1. Comment [r01-462](#) - Updating Figure 145-22 page 168 line 35, Figure 145-31 page 207 line 22 to sync with proposed text in comments [r01-286](#), [r01-287](#).
2. Addressing comment [r01-378](#) regarding the need to split Rsource_min/max to Rsource1_min, Rsource2_min and Rsource1_max, Rsource2_max for setting the correct PSE voltage at the PSE PI to allow adjusting Vsource to get VPort_PSE-2P at the PSI PI. [This comment is addressed in a simpler way.](#)

Per the latest changes we did to include equipment connector in the PSE PI and in the PD PI for unbalance tests the following changes should be made:

2. *Change figure 145-31 as follows:*

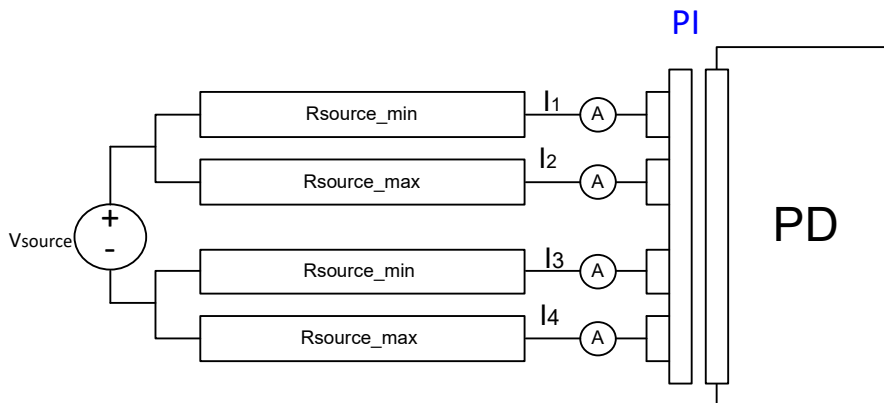
- a) Figure 145-22, the borders of the test verification model need to be clearly shown.
- b) Figure 145-31 and NOTE 1 in line 33 need similar adjustments.

1. *Change the title of Figure 145-22 from:*

"Figure 145-22—PSE PI unbalance specification and system resistance unbalance"

To:

"Figure 145-22—PSE current unbalance verification circuit"

3. *Change the title of Figure 145-31 from:*

"Figure 145-31—Icon-2P_unb and lunbalance evaluation model"

To:

"Figure 145-31—PD current unbalance verification circuit"

5. *Delete Note 1* ("OTE 1—Rsource includes the connector resistance at the PD PI, for which the maximum recommended value is 20 mΩ per contact.)
